Planning Commission Hearing Staff Report

McDonald's Design Review for Rebuild
Conditional Building and Site Design Review
(Petition 430-08-01)
1533 South State Street
Hearing date: June 11, 2008

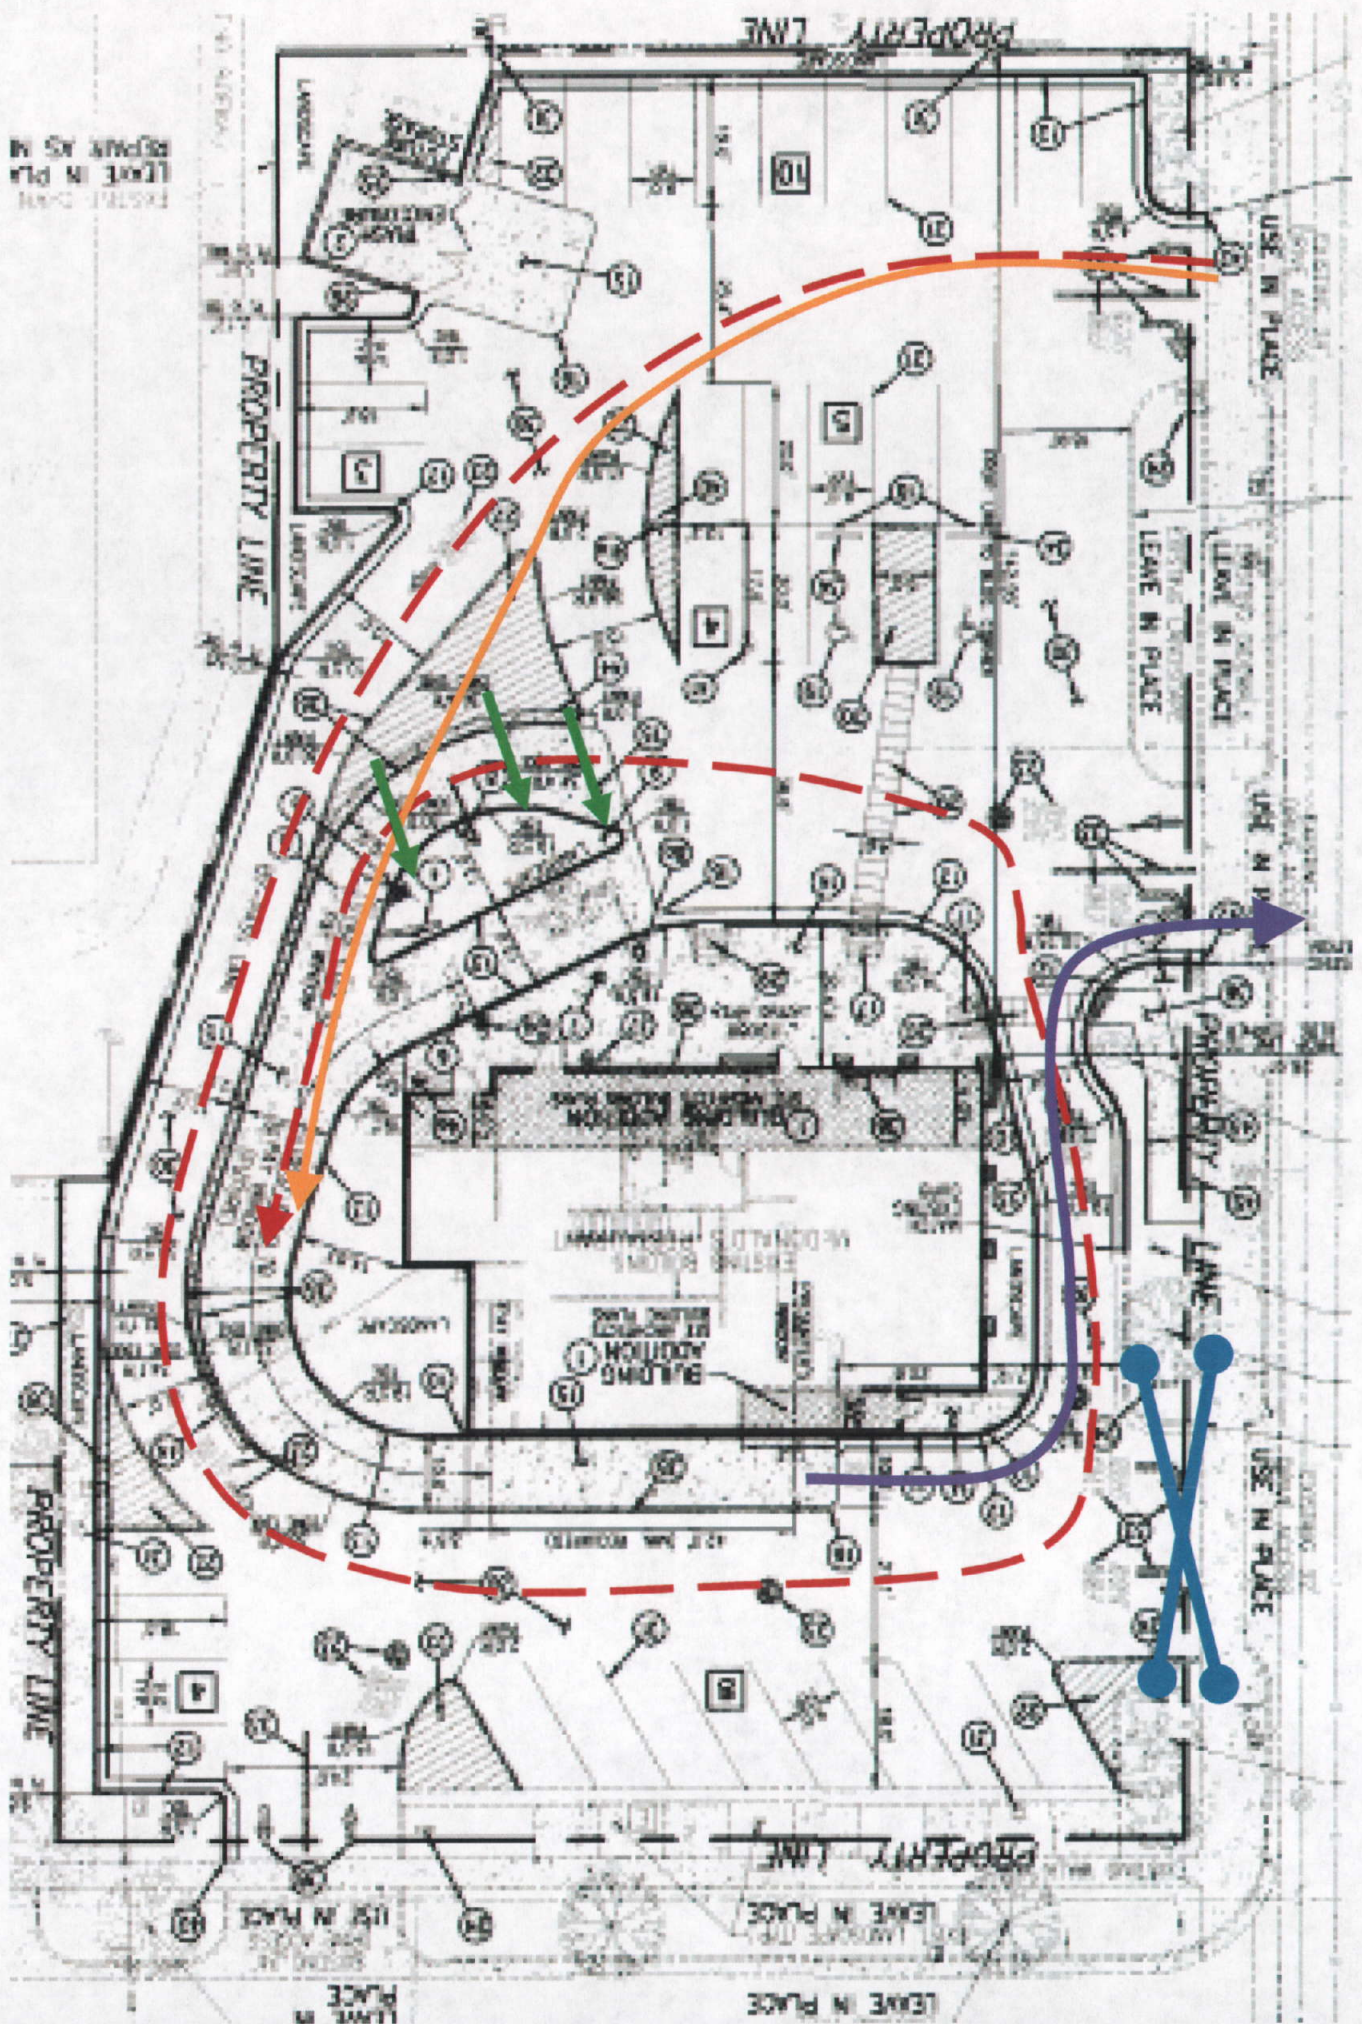
There is a lot of automobile congestion at this site and I don't think that this plan addresses it appropriately.

1. The red line shows the proper traffic flow (as proposed) for someone entering in the first driveway entrance coming from the South to the North, it is ridiculous. The proper flow to reduce congestion should be to along the yellow line. The proposed landscaping should be moved to increase the size of the center island (green arrows).

3. As the second drive up order lane is only "proposed" and may never go in, what landscaping will they add in its place until such time they decide to install it? In my opinion they should just install the two drive up system now as there is a long line of traffic in the mornings (before class) and at noon. (This is also why I would recommend that the first drive through lane be accessed from the South drive as there it provides more room on the site to stack automobiles away from the front door)
